University of Oregon
Oregon Bach Festival

GRADES AND ENTRANCES

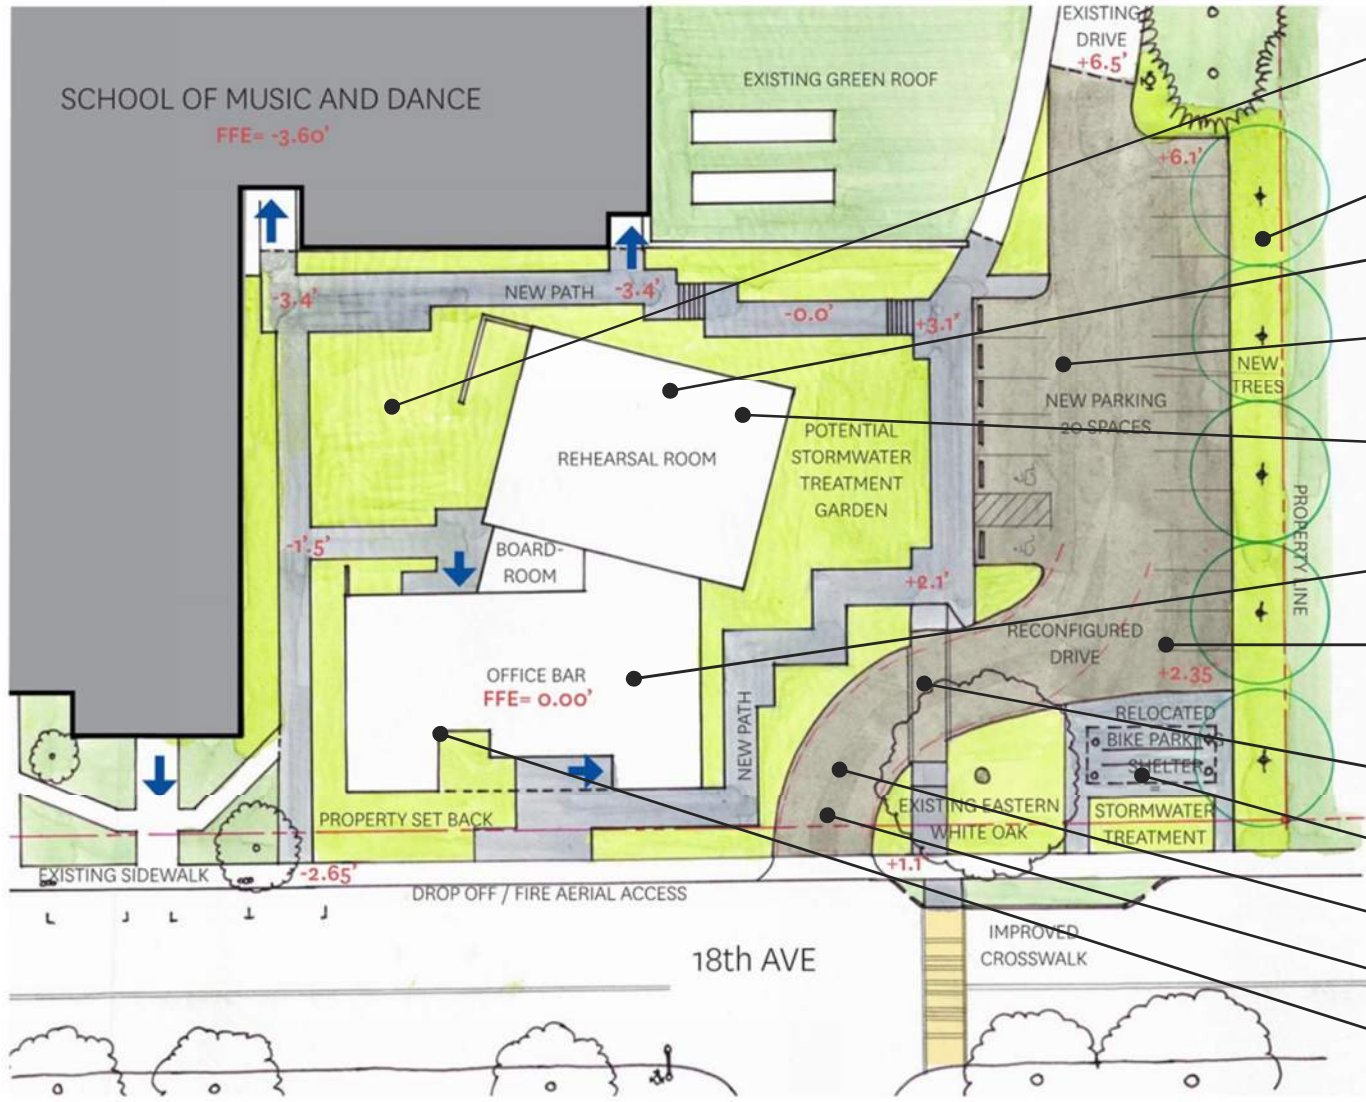
- Courtyard to be welcoming - consider shifting building east
- Consider Cemetery edge
- Ensure access needs for >100
- Consider decreasing parking
- Reconsider "tipped" Rehearsal Room
- Consider solar panels
- Consider instrument loading / account for service access
- Create clear pedestrian & bike routes
- Move bike parking closer to entrance
- Consider improvements to drive
- Reassess Driveway location
- Reassess relationship to 18th

GRADES AND ENTRANCES

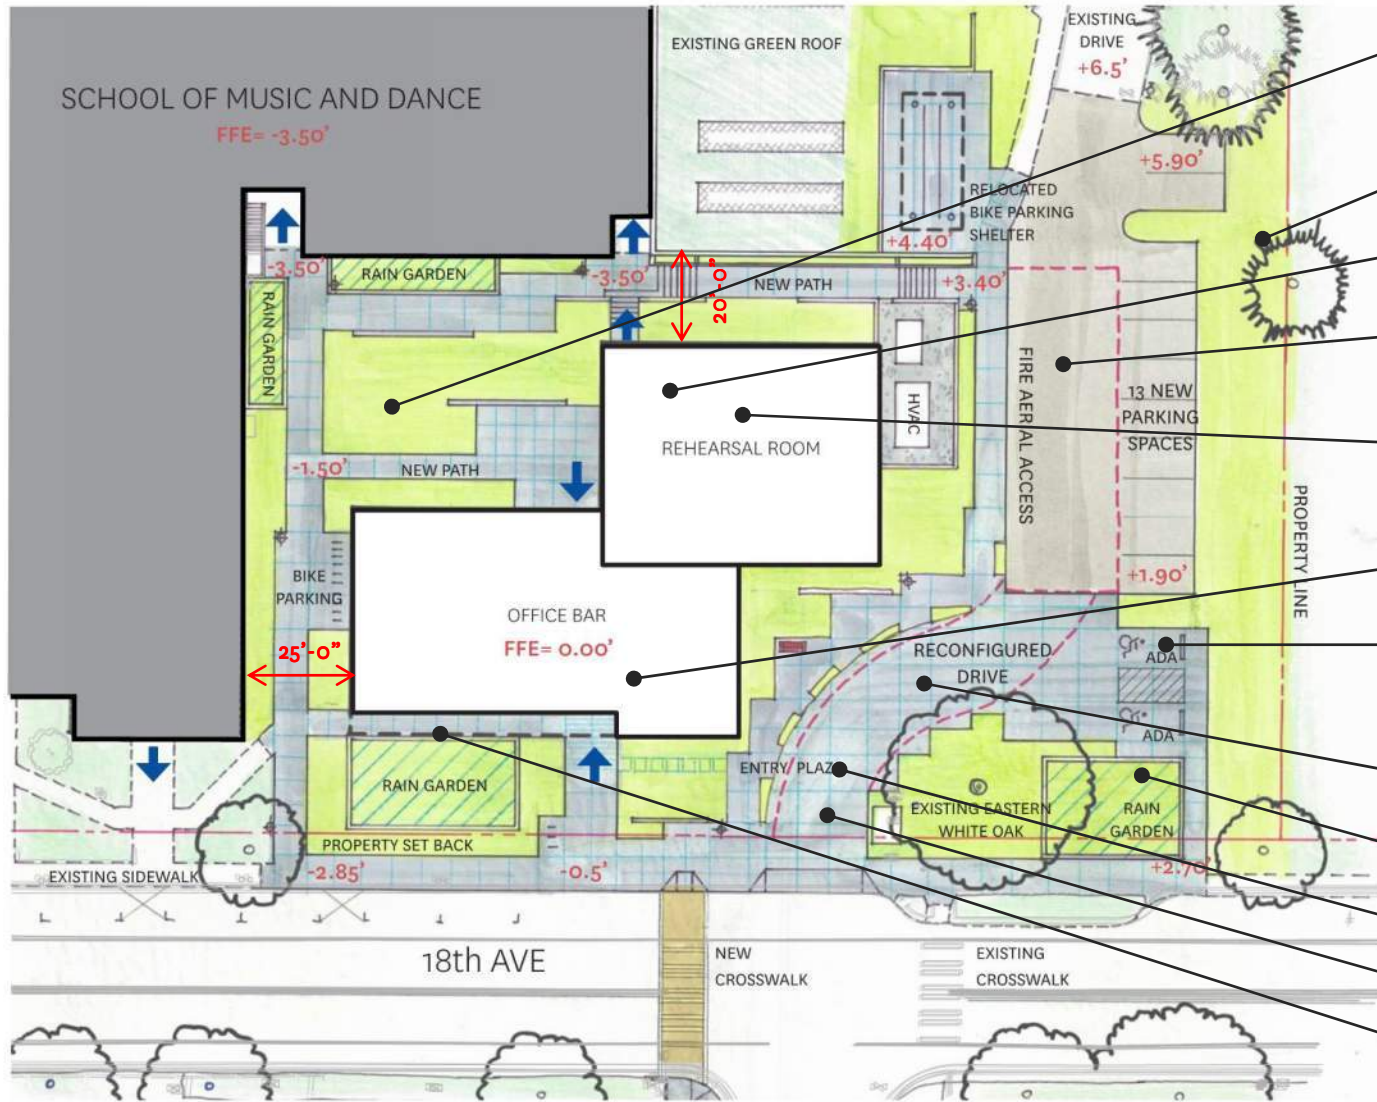
- Courtyard to be welcoming - consider shifting building east
- Consider Cemetery edge
- Ensure access needs for >100
- Consider decreasing parking
- Reconsider "tipped" Rehearsal Room
- Consider solar panels
- Consider instrument loading / account for service access
- Create clear pedestrian & bike routes
- Move bike parking closer to entrance
- Consider improvements to drive
- Reassess Driveway location
- Reassess relationship to 18th
